PLANNING COMMISSION MEETING AGENDA REGULAR MEETING

January 25, 2022

SUBJECT: PRELIMINARY SITE PLAN REVIEW (SP JPLN2021-016) - Proposed The Westington II, South of Wattles, East of Crooks (870 Barilane Drive; PIN 88-20-21-101-009), Section 21, Currently Zoned NN (Neighborhood Node "I") District

Preliminary Site Plan Review For City of Troy, Michigan

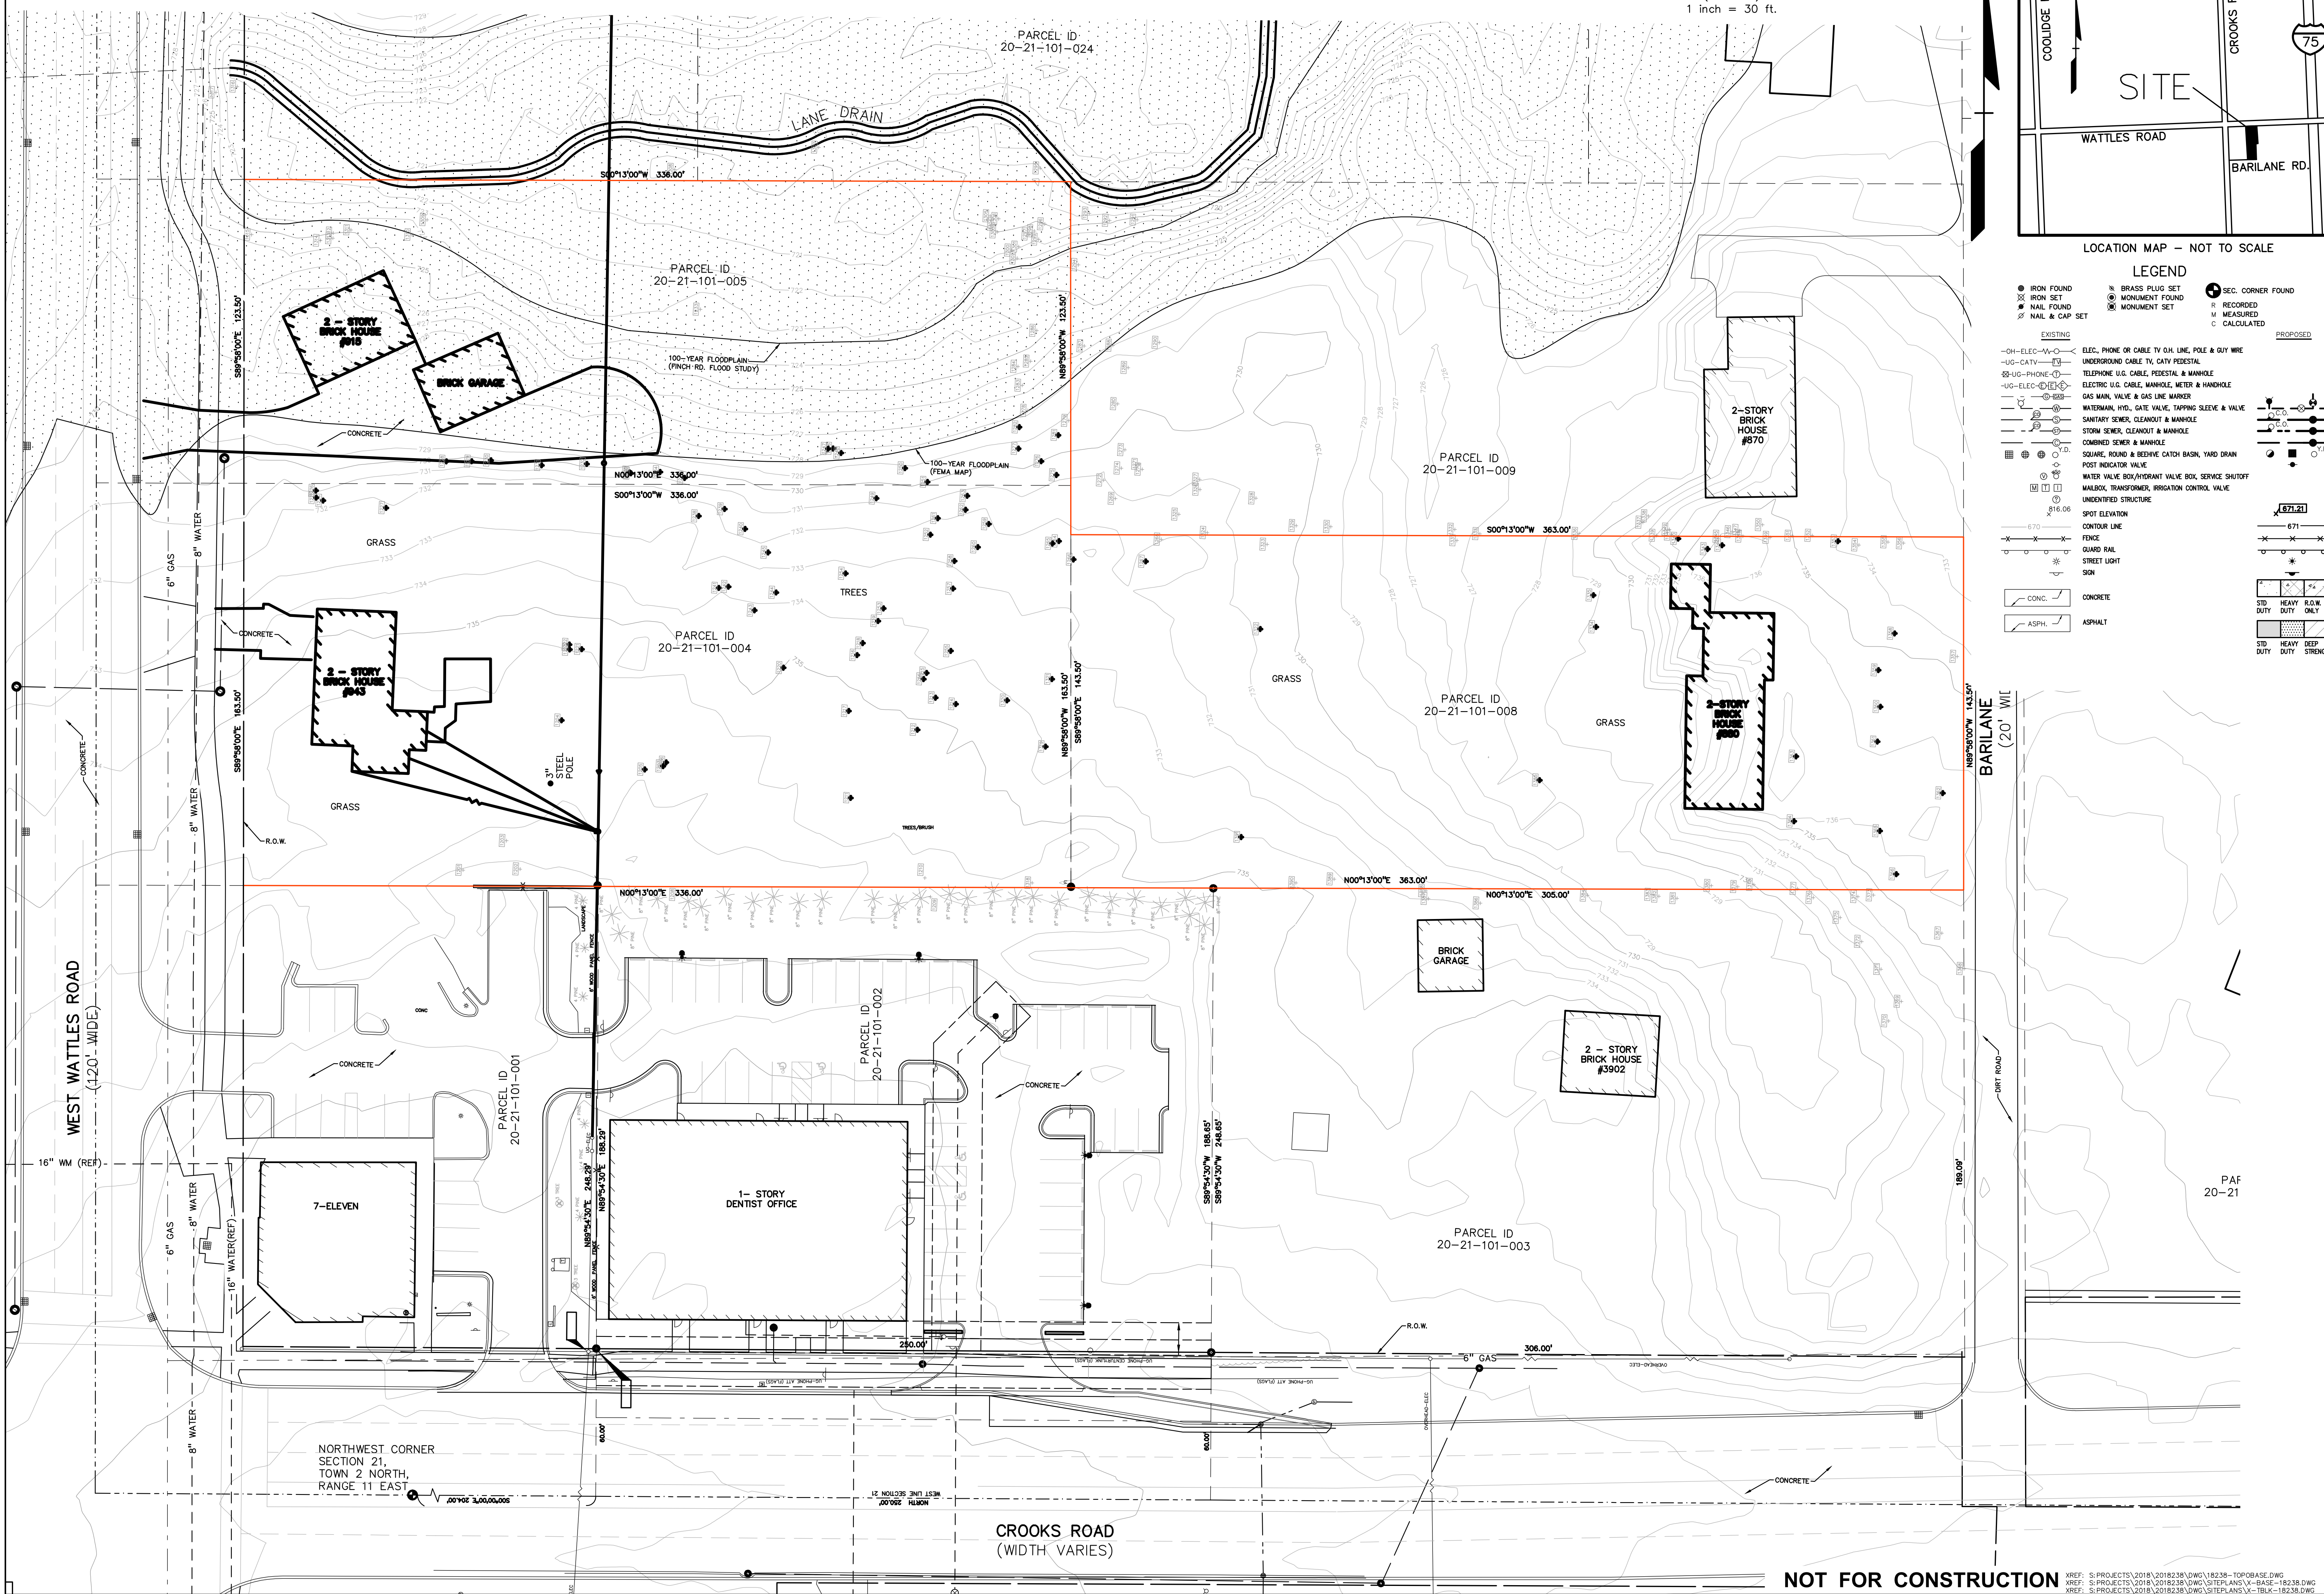
Topography: A topographic survey has been provided on sheet C-2.0. Elevations decrease in the northwest corner of site towards the floodplain.

Composite Site Plan

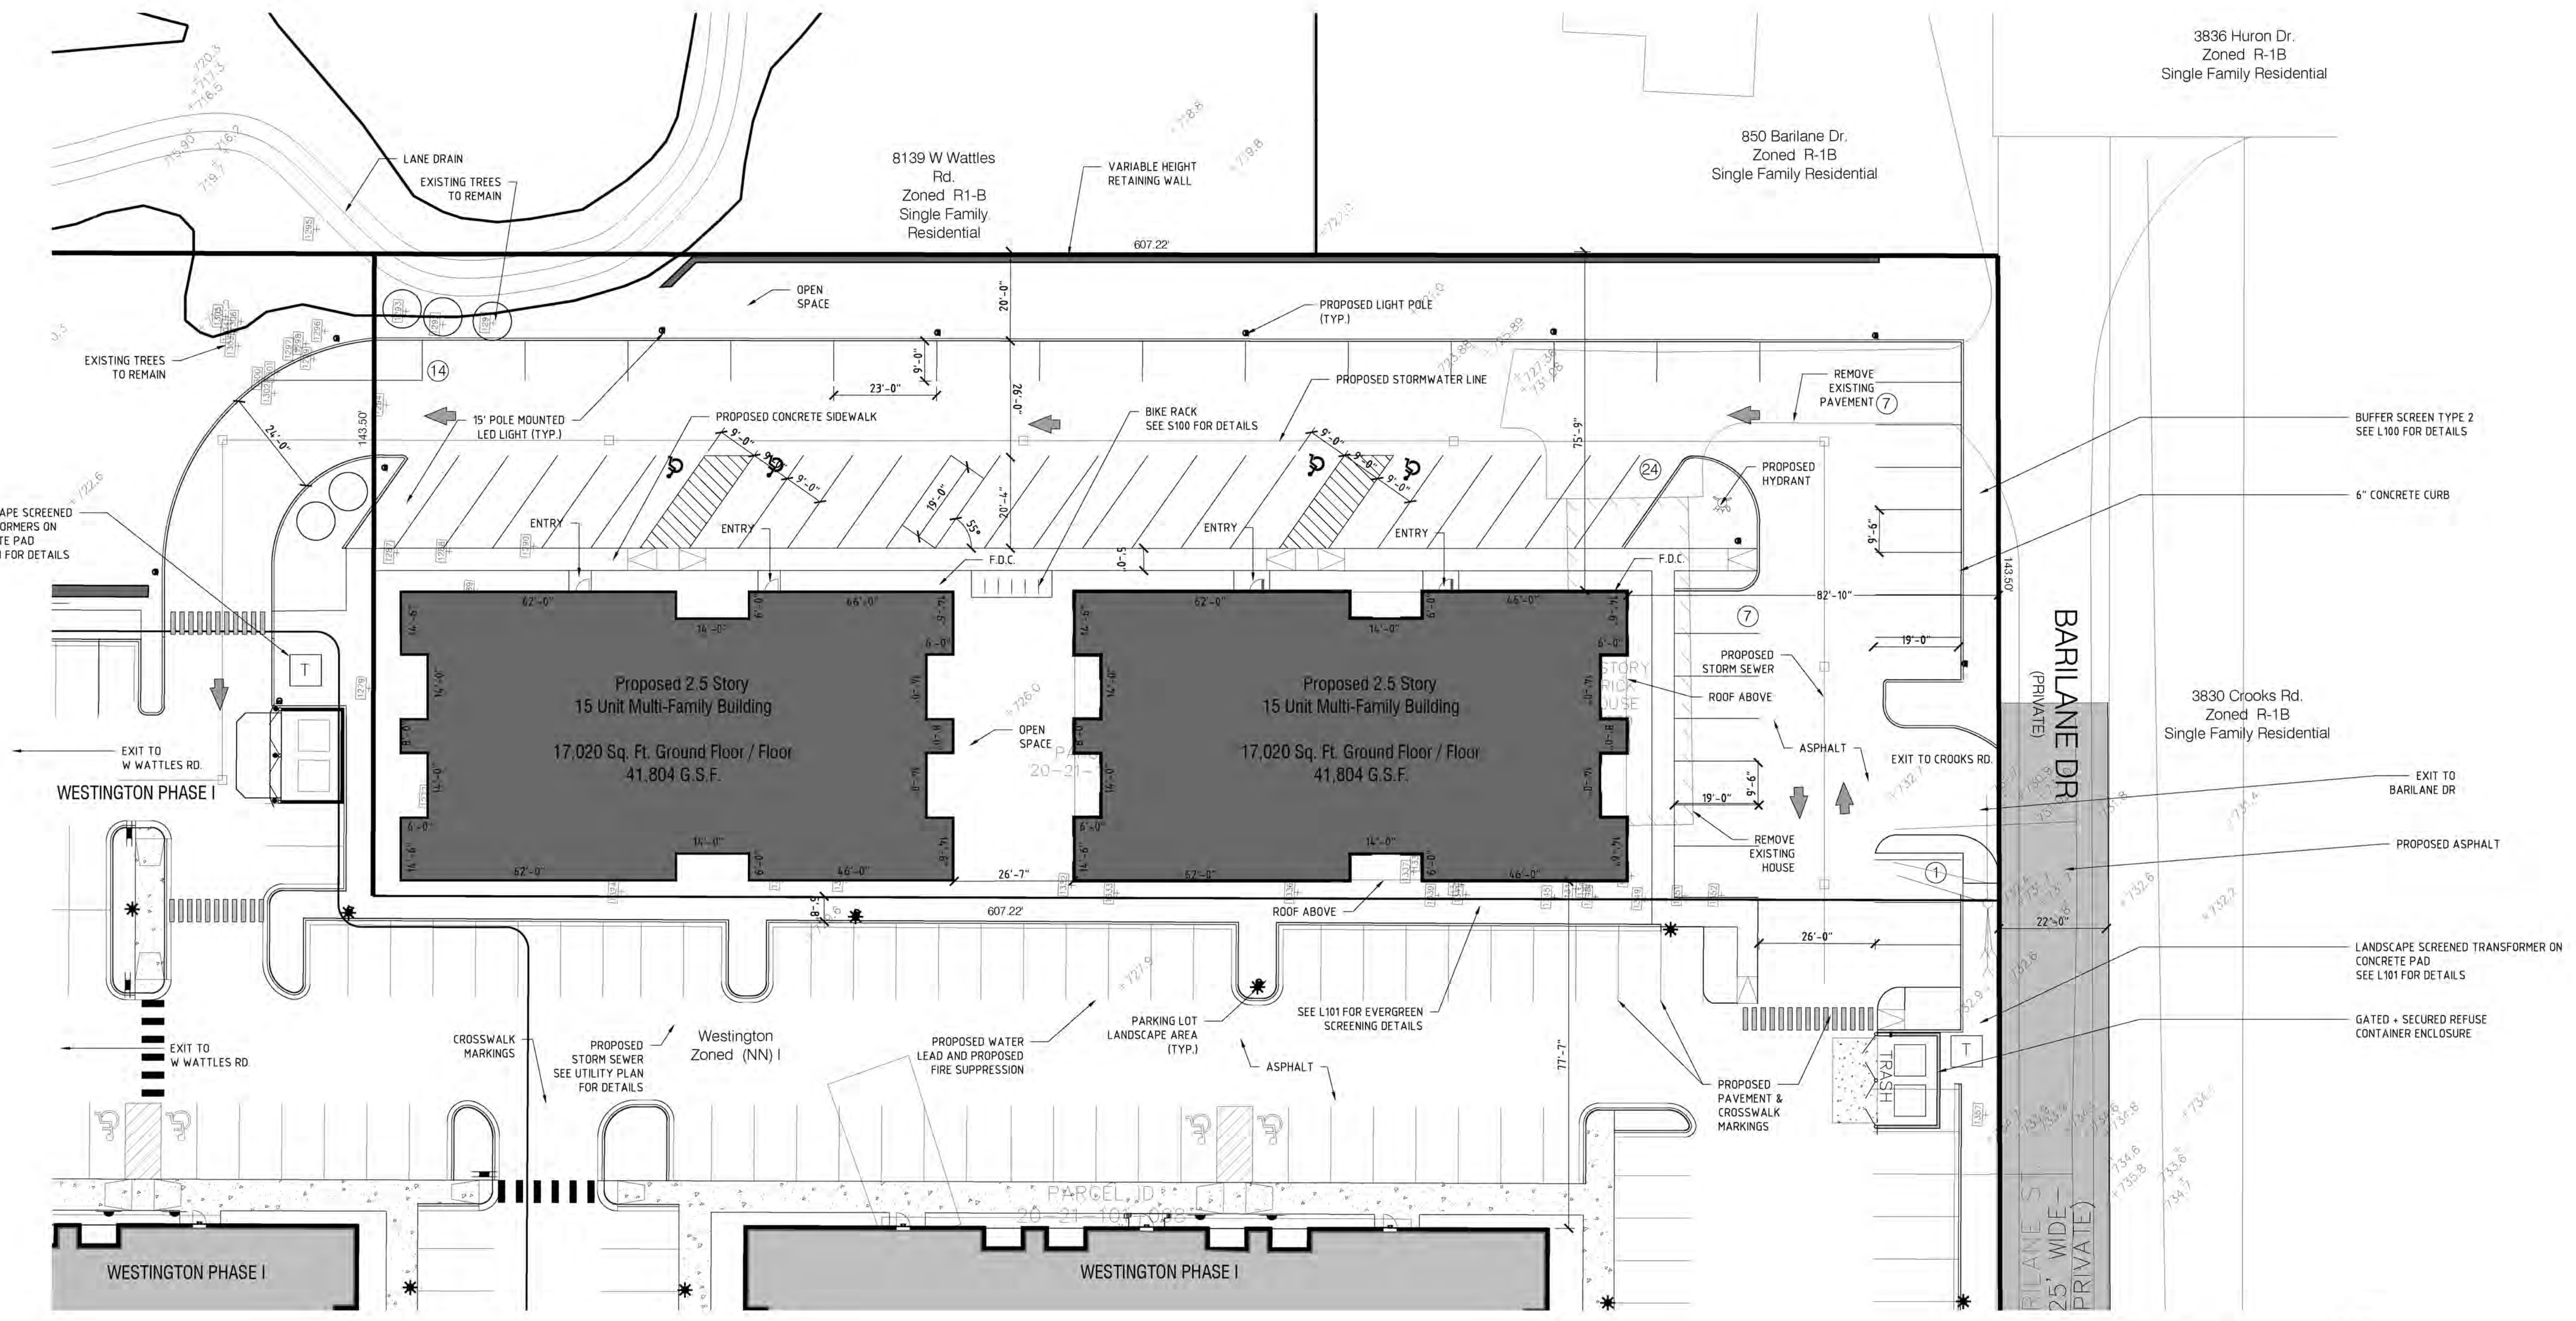
Required	Provided
Residential (General): 2 spaces per unit	Phase 2: 30 units = 60 spaces Combined: 234 spaces	Phase 2: 57 spaces including 4 barrier free spaces per Sheet S100 Composite Site Plan Combined: 238 spaces
Barrier Free	4	4
Bicycle Parking	2	
Loading	0	0
Total	60 spaces (phase 2) Combined: 234 spaces	238 spaces

Phase 2 on its own is deficient of parking. However, if the sites are combined, the overall site parking complies but the applicant has provided only 4 guest parking spaces for the entire development. The applicant and Planning Commission should discuss the need for additional guest parking.

Items to be Addressed: 1). Combine site; and 2). The applicant and Planning Commission should discuss the need for additional guest parking.

1 Tree Removal & Preservation Plan
SCALE: 1" = 20'

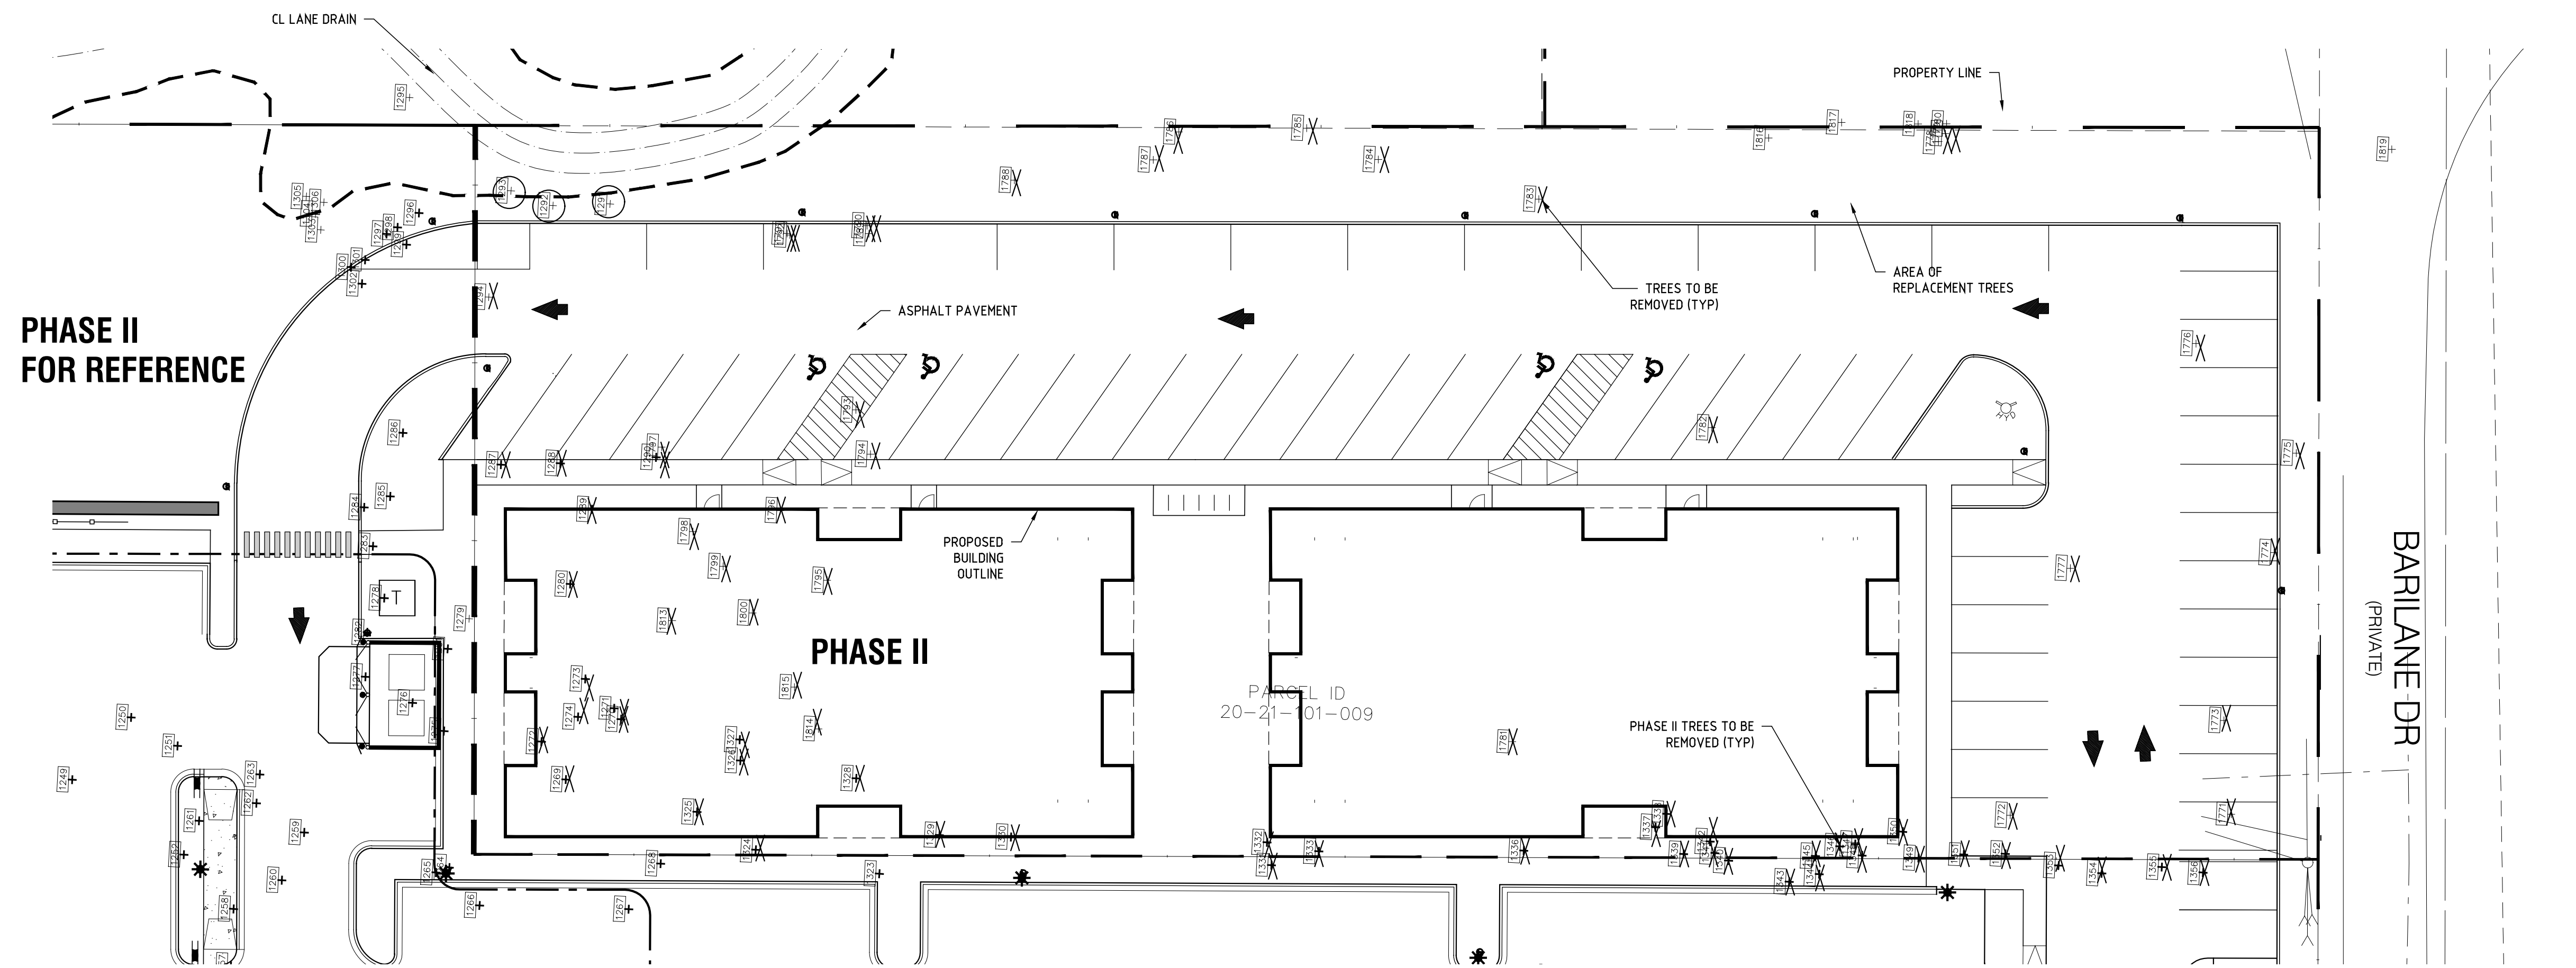
Woodlands: A tree inventory and replacement plan has been provided on Sheet L100, with replacement trees shown in the landscape plan on Sheet L101. The applicant notes that a total of 806 inches will be removed, requiring 486 inches of replacement.

1. Can the applicant shift the building or reduce the size to preserve additional trees?
2. The need for additional guest parking.
3. Compliance with Design Standards
4. Compliance with Site Plan Review Standards
